**Title:** Reply to N4-031152 (S3-030672) on use of authentication re-attempt IE

**Source:** 3GPP SA3

⌘ **33.102 CR CR-Num** ⌘ rev **-** ⌘ Current version: **3.7.0** ⌘

<b>Title:</b>	⌘ Additional Parameters in Authentication Failure Report		
<b>Source:</b>	⌘ Ericsson		
<b>Work item code:</b>	⌘ Security Architecture	<b>Date:</b>	⌘ 27-Feb-01
<b>Category:</b>	⌘ <b>C</b>	<b>Release:</b>	⌘ Rel-4
	Use <u>one</u> of the following categories: <b>F</b> (essential correction) <b>A</b> (corresponds to a correction in an earlier release) <b>B</b> (Addition of feature), <b>C</b> (Functional modification of feature) <b>D</b> (Editorial modification)		Use <u>one</u> of the following releases: 2 (GSM Phase 2) R96 (Release 1996) R97 (Release 1997) R98 (Release 1998) R99 (Release 1999) REL-4 (Release 4) REL-5 (Release 5)
	Detailed explanations of the above categories can be found in 3GPP TR 21.900.

**Figure 13: Reporting authentication failure from VLR/SGSN to HLR**

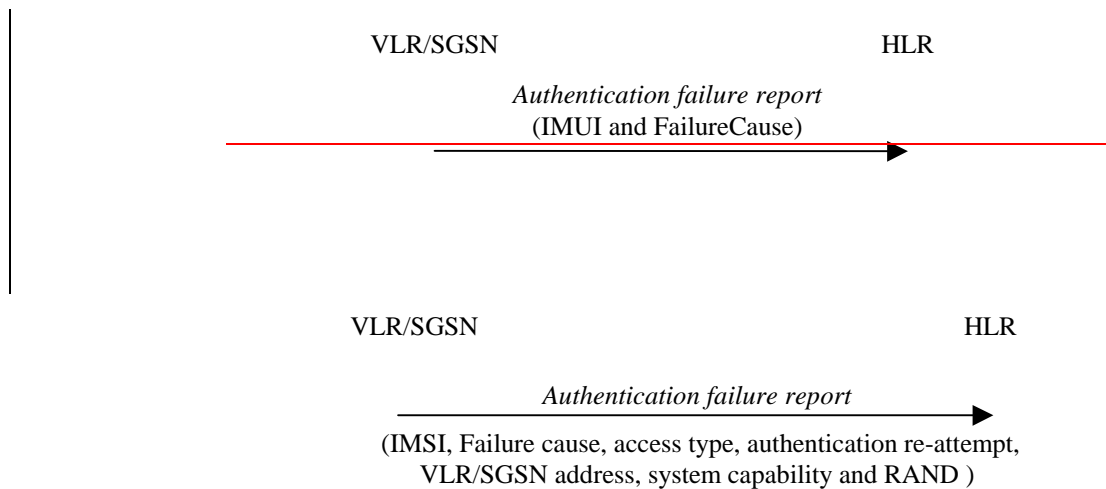
The procedure is invoked by the serving network VLR/SGSN when the authentication procedure fails. The *authentication failure report* shall contain:

1. ~~the s~~Subscriber identity, ~~and~~
2. ~~a f~~Failure cause code. The possible failure causes are either that the network signature was wrong or that the user response was wrong.
3. Access type. This indicates if the authentication procedure was initiated due to a call set up, an emergency call, a location updating, a supplementary service procedure or a short message transfer.
4. Authentication re-attempt. This indicates whether the failure was produced in a normal authentication attempt or it was due to an authentication reattempt (there was a previous unsuccessful authentication).
5. VLR/SGSN address.
6. System Capability. This indicates the security capability of a serving node and whether it is a 3GPP or 3GPP2 system.
7. RAND. This number uniquely identifies the specific AV that failed authentication.

The HE ~~may decide to cancel the location of the user after receiving an authentication failure report.~~ shall store the received data so that further processing to detect possible fraud situations could be performed.
